Draft Determination

Overview document response

**Our response to Ofgem's
assessment of regulated network
companies' RIIO-3 (2026-2031)
price control plans**

Chart 1 – UK market sector multi-factor productivity (2022=100)

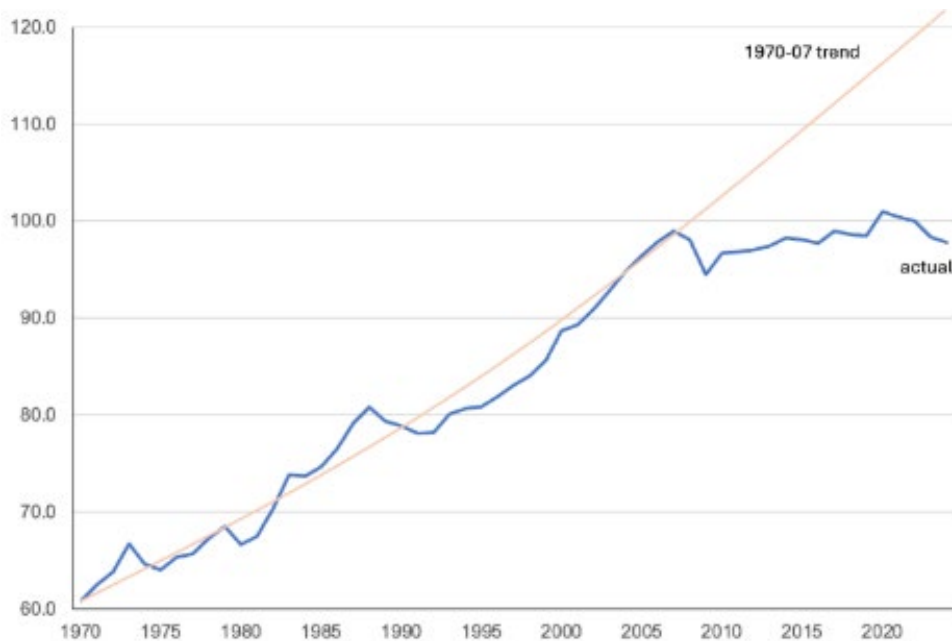
89. National Gas Transmission, along with the other members of Future Energy Networks (FEN), submitted benchmarking evidence and an assessment of sectoral factors performed by Economic Insight with our business plans. This recommended a range for the threshold of 0.2% to 0.8% per year, the midpoint being 0.5%. Economic Insight (EI) also demonstrated there was little evidence that regulated entities, particularly gas networks, can outperform the general productivity benchmarks. This is primarily the case due to the nature of the industry, (evidence shows that only high tech businesses have outperformed the index), and the limited evidence that regulation can materially mitigate the drivers of low productivity in the UK.

90. Networks have been consistent in demonstrating evidence that since the financial crisis of 2008, productivity levels have struggled to meet historical trends and there is limited evidence to suggest a reversal of this trend in the near future, nor that regulated businesses can be completely immune from this trend.

- **Error 2:** The removal of three outlier observations in productivity data (2008, 2009 and 2020) in periods of 'low productivity' rather than including complete business cycles and treating 'high productivity' outliers in the same way. These years were not removed from the RIIO-2 assessment. Two statistical methods applied by Economic Insight to assess outliers show contradictory evidence as to whether they are somehow 'unprecedented'. Furthermore, the periods from which Ofgem draws its 0.1%-1.3% range is based on four periods of entirely positive GDP growth and hence is upwardly biased. This approach appears contrary to Ofgem's justification for utilising a full data set back to 1970 cited in para 8.28 of the DD Overview Document, is asymmetrical, inconsistent and could be interpreted as arbitrary. **Correcting for this error restricts the upper bound of the range Ofgem proposed to 0.9%**

- **Error 3:** Ofgem has placed disproportionate weight on unsubstantiated arguments to select a target from the upper end of its range, including Ofgem's view that networks will benefit from above average technological change, rather than applying a consistent weighting to all factors. This infers that Ofgem considers the gas sector will benefit from technological change more than the UK average and must, to meet Ofgem's target, be considered one of the most innovation sectors of the economy. Economic Insight has provided survey evidence that demonstrates if anything, gas networks should see lower net productivity improvements from new technologies than nearly every other industry. Furthermore, only matters that relate to the upper bound of Ofgem's range are considered, when there are several reasons to consider a more conservative target for RIIO3. For example, there have been several technological developments since the financial crisis that have not resulted in higher productivity. Furthermore, UK productivity growth has been low and stagnant since 2008 and are unlikely to unwind over RIIO-3 and as previously referenced, regulation is unlikely to mitigate the impact on gas networks of the factors causing this slowdown. **This is an asymmetric assessment that risks underfunding networks in RIIO-3. Correcting for this error requires the adoption of a mid-point from the final range. The midpoint of Ofgem's 'narrow' range is 0.7%**

Figure 1

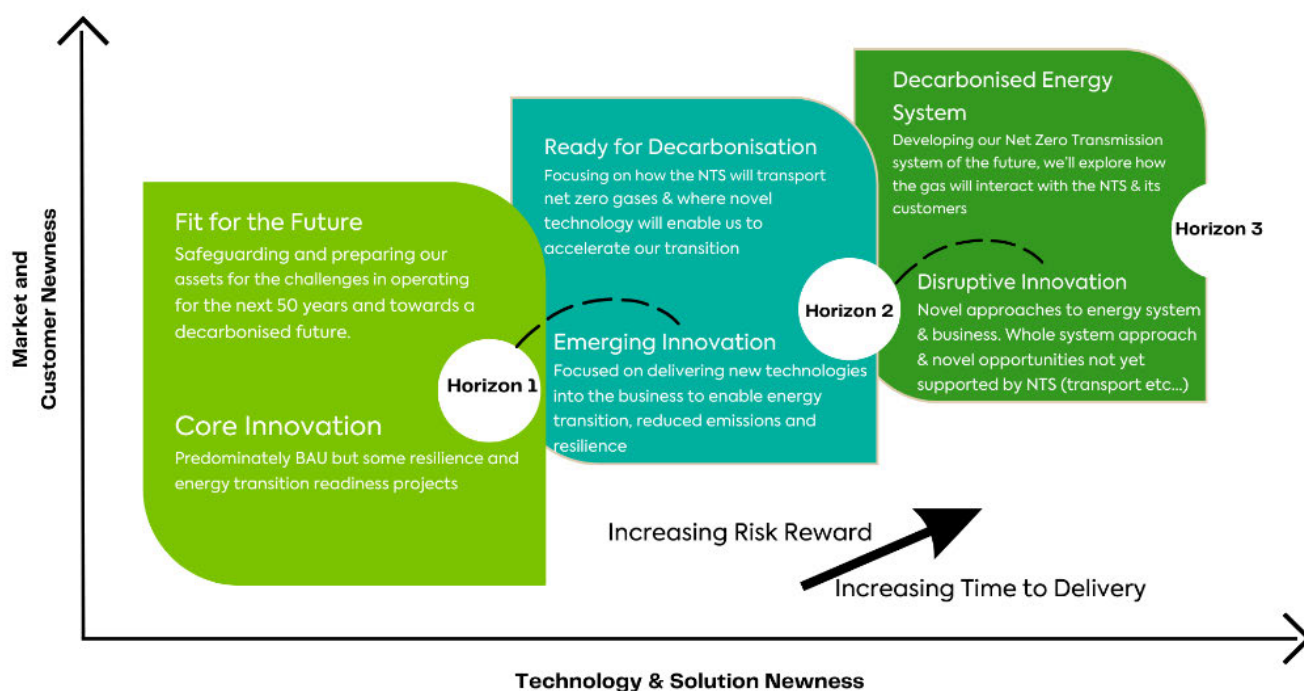
99. We do not agree with the definitions of NIA and SIF funding shared in the webinar on 11/08/2025. We have understood incremental innovation to need to be funded as BAU not through NIA. NIA should be for work that is consumer focussed, higher risk and harder to progress through business funding. In terms of horizons we believe:

- Horizon 1 should be BAU
 - Horizon 2 should be NIA
 - Horizon 3 or large-scale demonstration should be SIF
